## ELEVATOR SERVO MOUNT ADDENDUM

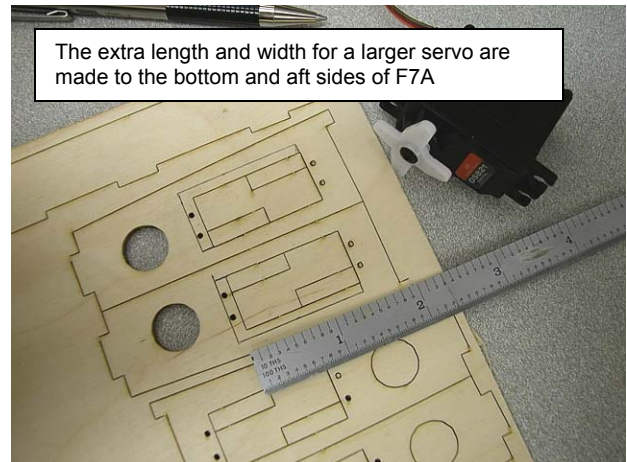
On page 34 of the Electra instruction manual, there is mention of two additional F7A formers that will allow the installation of a larger, standard size servo such as the Spektrum DS821. These formers are found on the 1/8" Baltic ply sheet LC028. In the event that the LC028 supplied with your kit has the extra formers but with cutouts for the mini sized servos only, you can quickly modify two of the formers to accept a larger servo.

- Measure your servo and draw the extra width and length lines directly onto the Baltic parts. Note that the length is increased towards the small lightening hole at the aft end of F7A and the width is increased towards the bottom of F7A indicated by the small tab at the front.

- Use a Drum sander to take away most of the material then a razor knife and scuff board to clean up the corners. Complete the rest of the steps as per the manual.
